SURVEY FOR  
PHILLIP B. AMPEL  
CHERYL Z. AMPEL  
3149 HUDSON POND LANE  
MARIETTA, GEORGIA  
TOTAL AREA= 0.344± ACRES  
OR 15,001± SQ. FT.

**PETITION No.:** V-78

**COMMENTS**

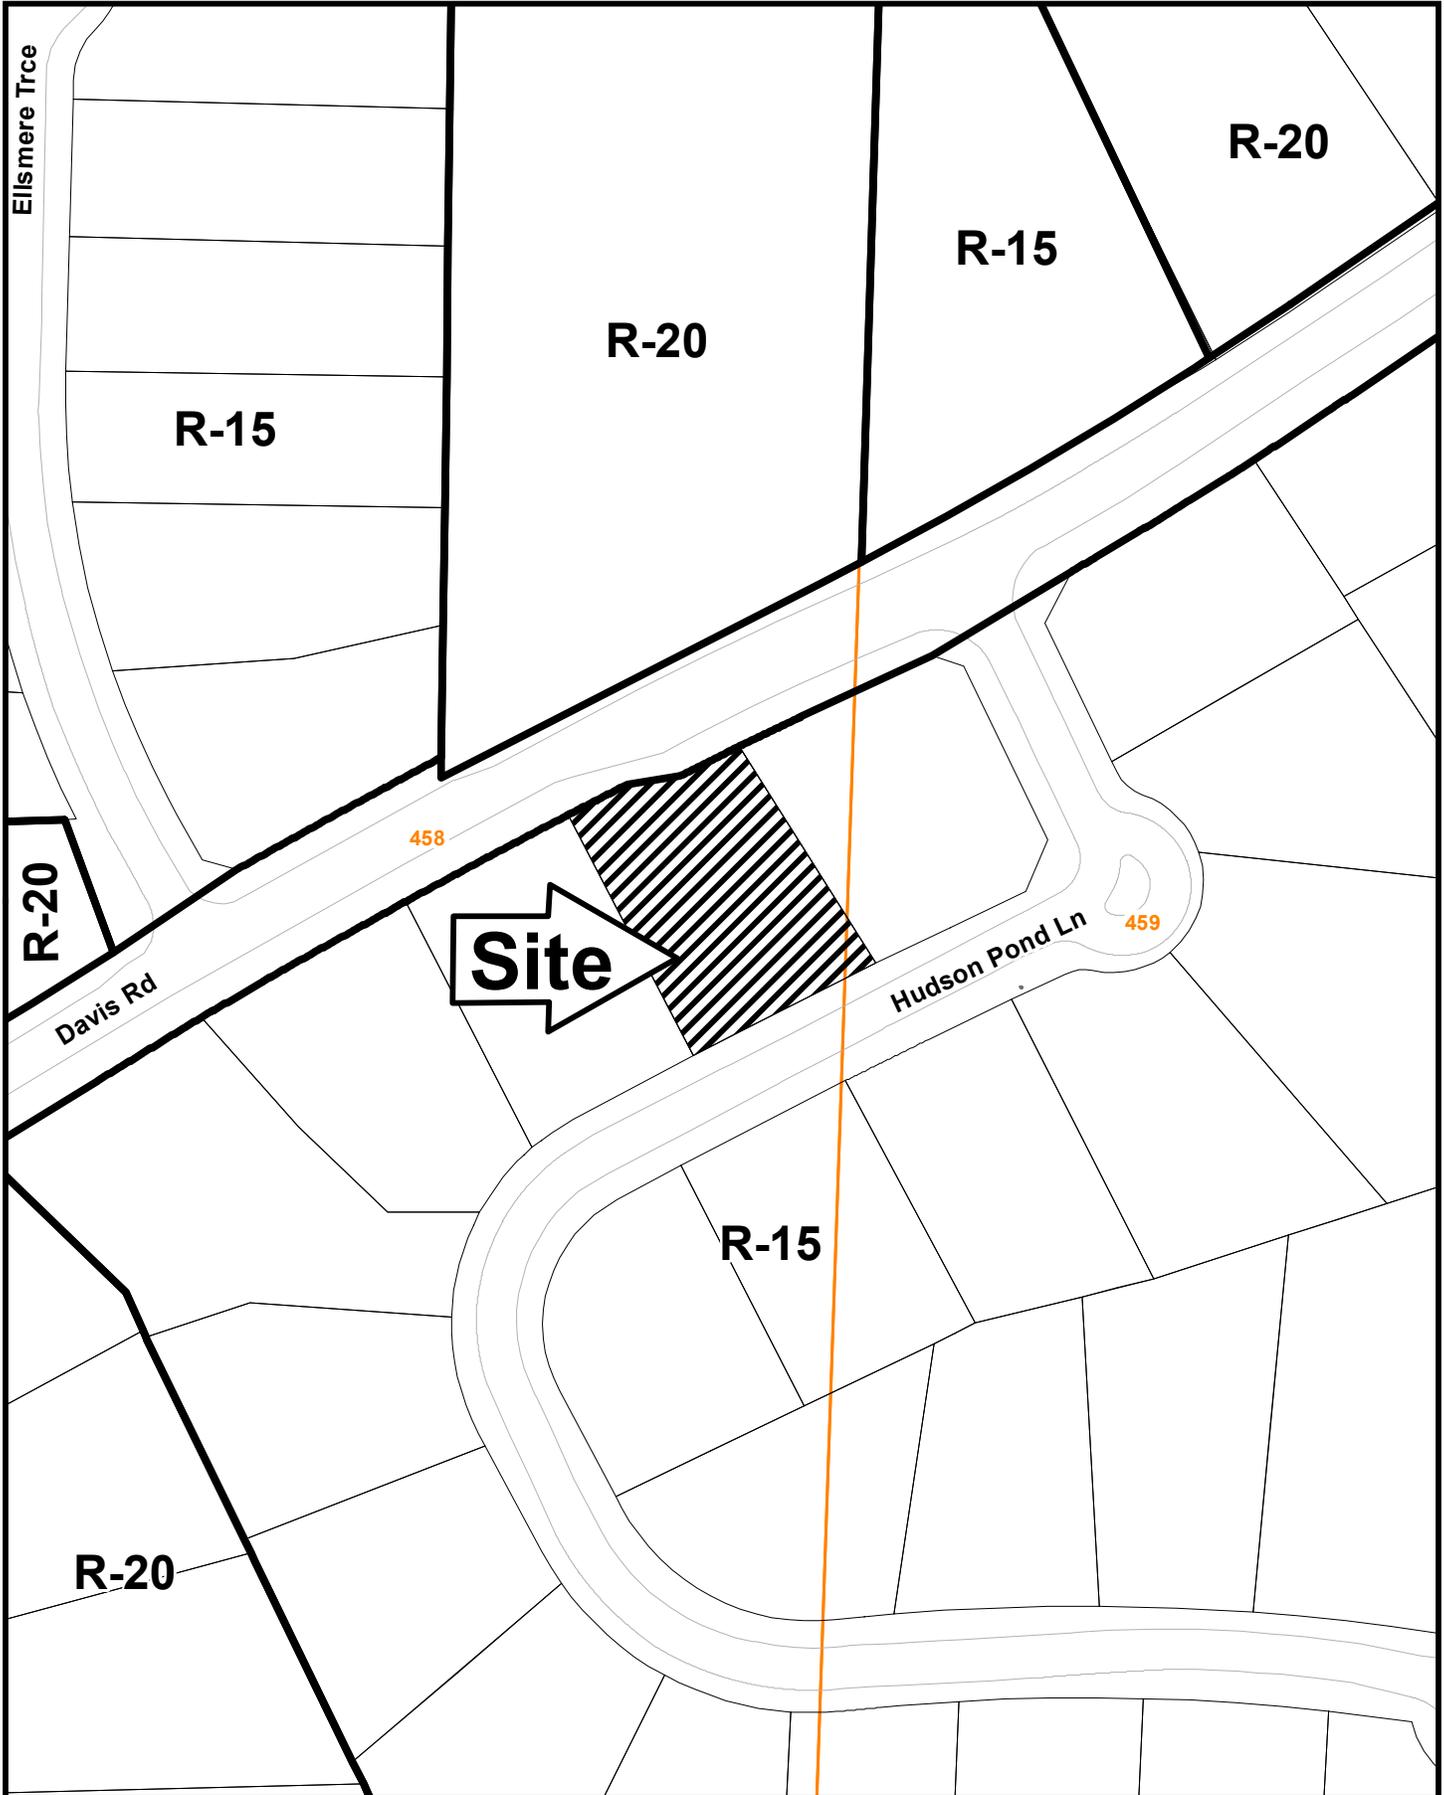
**SITE PLAN REVIEW:** If this variance request is approved, a subdivision plat revision must be recorded prior to the issuance of the certificate of occupancy showing all improvements on the lot along with any approved setback reductions, and referencing the variance case in the standard plat revision note. The surveyor must submit the plat to the Site Plan Review Section, Community Development Agency for review an approval prior to recording. Call 770-528-2147.

**STORMWATER MANAGEMENT:** The proposed improvements will exceed the allowable impervious coverage limit by 1,663 square feet. Approval should be subject to installation of dry-well(s) to mitigate the impervious overage with a site plan to be approved by Stormwater Management Divison prior to permitting. A hold harmless agreement will be required for the existing encroachment into the recorded 20' drainage easement.
